Job Code:	M920035 – 26-008	Product:	Lineage LVT1
Date:	5/20/2026	Repair Time:	0.05 h

This bulletin describes the procedure to install the Compressor Power Relay Upgrade on affected Lineage units. The upgrade routes the A/C compressor positive power feed through a dedicated 120-amp relay, removing the compressor load from the control board. The upgrade is supplied as SDG kit 5000041 (GDRV PN 710676).

Fig. 1 — New 120-amp relay — compressor positive power wire and 12" power wire connections.

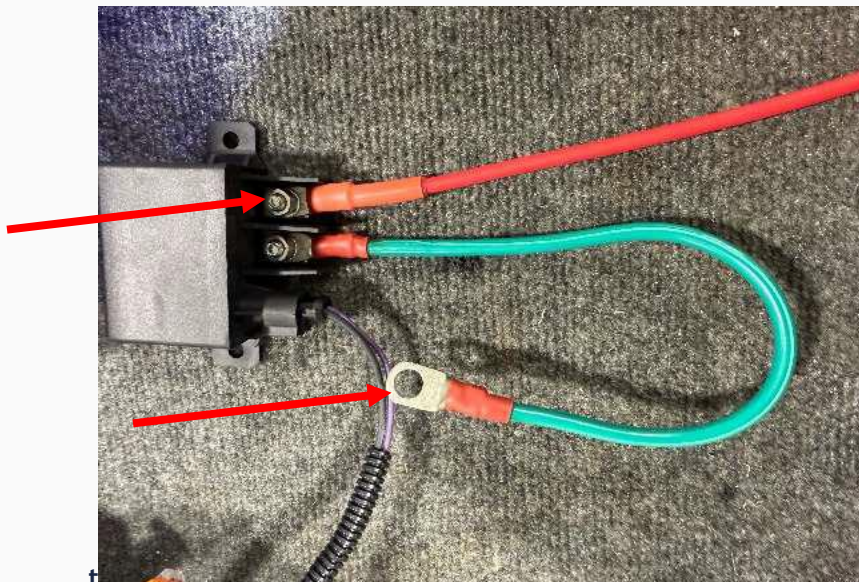
Step 1 — Access the chassis power strip or breaker where the compressor positive power wire is connected. Disconnect the wire and reconnect it to the new relay as shown.

Fig. 2 – Control board — purple wire terminal location.

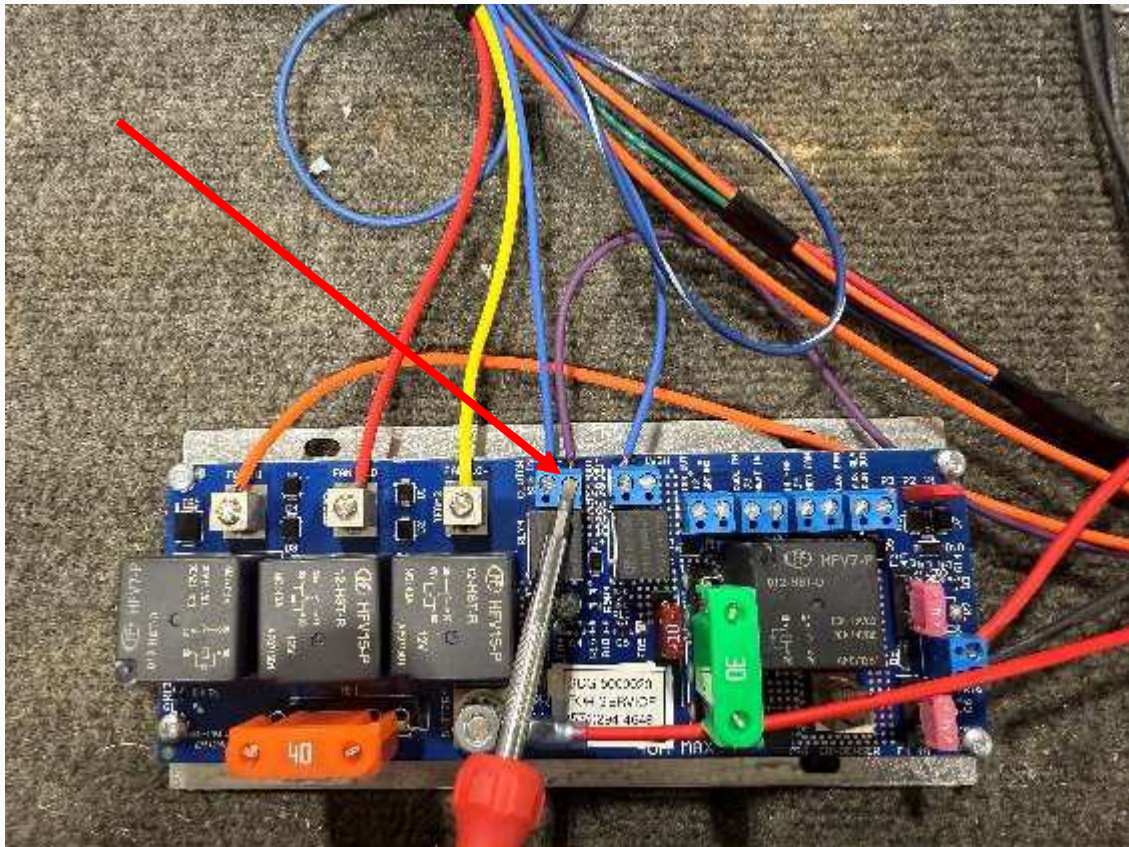
Step 3 – Remove the purple wire from the control board using a 1/8" screwdriver tip as shown.

Fig. 3 — WAGO connector splice — removed purple wire and short purple wire to control board.

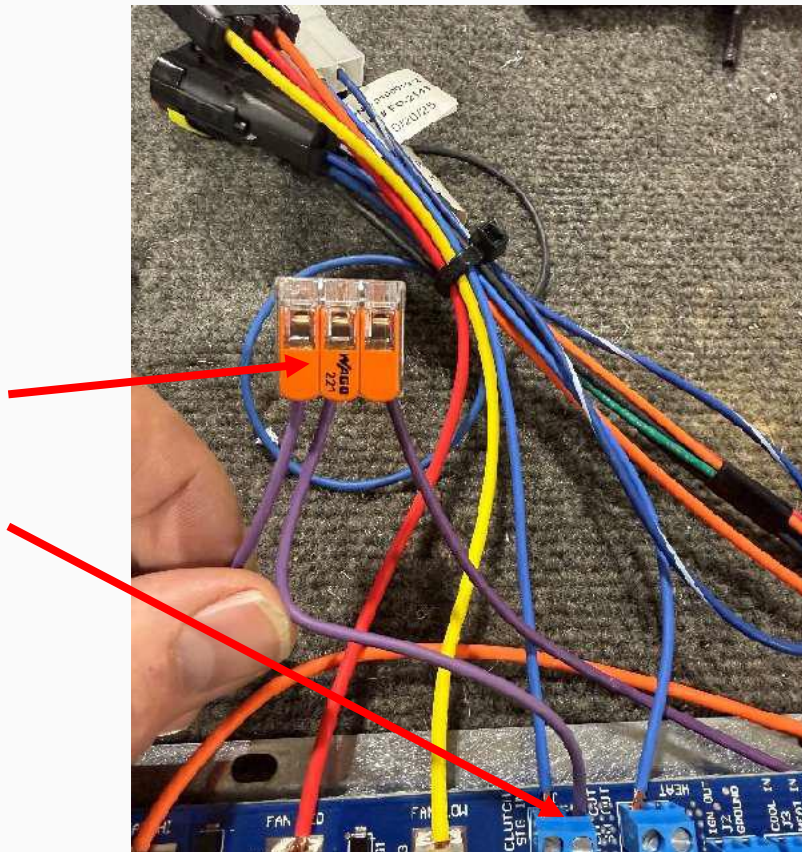
Step 4 – Connect the removed purple wire to the supplied WAGO connector as shown.

Step 5 – Connect the short purple wire on the WAGO connector back onto the control board in the same position the original purple wire was removed from.

Note: The replacement purple wire must go into the exact same control board position as the wire removed in Step 3.
